Comfit Composite Knit LTD (Unit 2)

Amtola, Kathgora Bazar, Ashulia, Savar, Dhaka
(+23.907331N, 90.288456E)
29th March 2014

Executive Summary (Continued)

Typical column layout

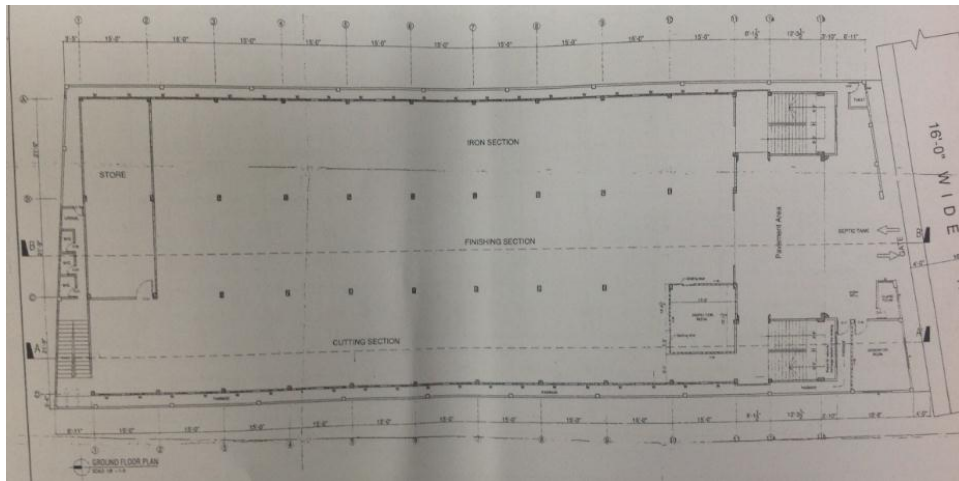
Due to the heavy floor construction in the toilet areas at 1st to 3rd Floors, outline calculations indicate that the columns on Gridline 2 are highly stressed to levels that require immediate review

Area highlighted to be vacated and Specific design check to be carried out on columns at ground floor level which support heavy toilet floor construction

Outline calculations indicate that column sizes appears to be smaller than required by code for the applied dead and live load, assuming typical concrete strength

Building Engineer to perform detailed calculations and concrete tests to prove column size and (if required) :

- Reduce loads further by preparation of allowable floor loading plans
- Carry out strengthening works

Typical floor plan showing cantilevering half landings

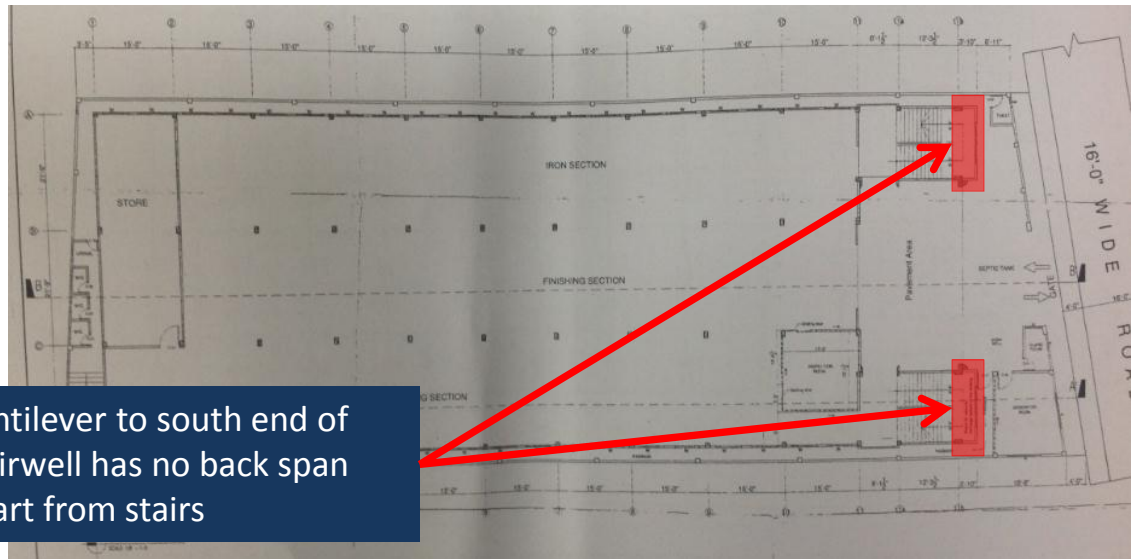
Adequacy of stairwell cantilevers

Cantilever to south end of stairwell has no back span apart from stairs

Engineer to verify as-built arrangement of stairwells, including cantilever beam, landing slab and supporting column adequacy.

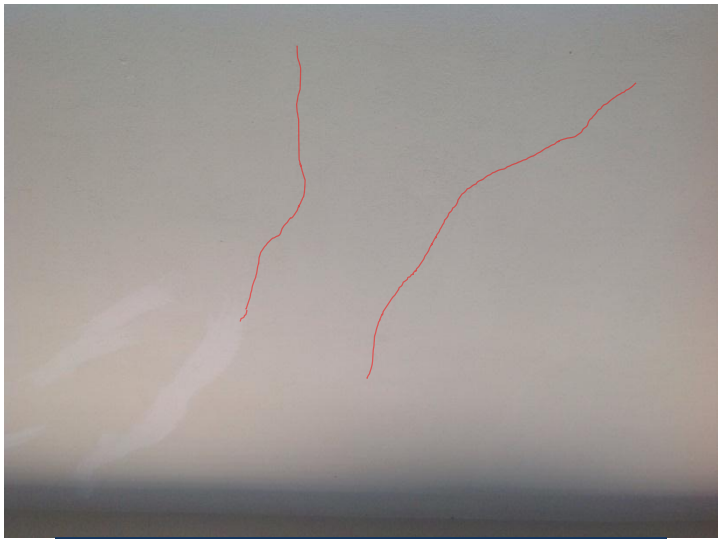
Hairline cracking to beams and soffits of slabs

Cracking at soffit to beam supporting 2nd floor slab

Cracking at soffit to fourth floor slab

Typical plan showing crack locations on suspended slabs

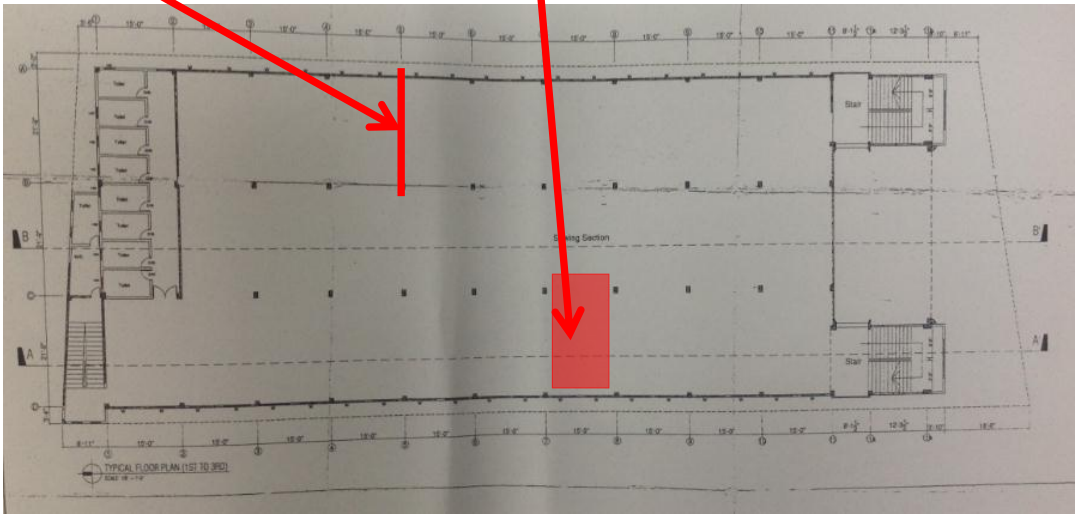
Cracking to concrete structure
